TECHNICAL SERVICE BULLETIN

TSB#: 13-001 Job Code: 9801152 Flat Rate: 0.2 HOUR

Install power cord hook and label

2013 Jay Flight Travel Trailers

Fig. 1a

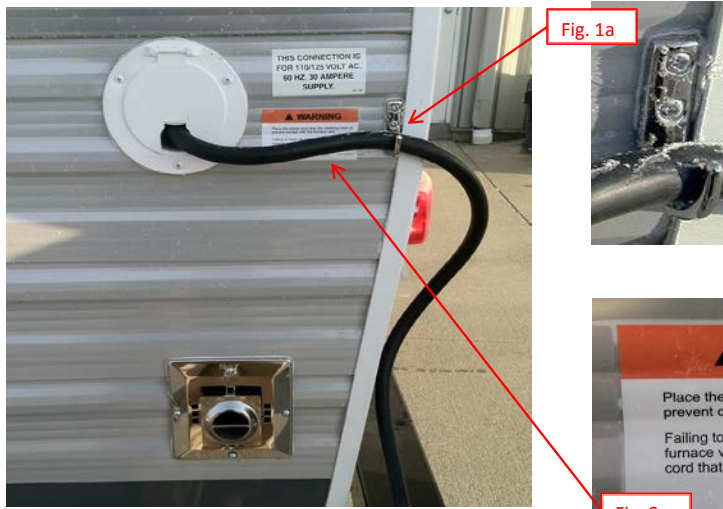
1. Apply putty tape to the back of the hook. Install the hook at the rear trim edge and at a height that will adequately keep the cord away from the furnace vent (**Fig. 1a**).
2. Using the isopropyl alcohol and a shop rag, clean the area between the hook and the cord access door. Allow to dry. Apply the warning label between the hook and cord access (**Fig. 2a**).
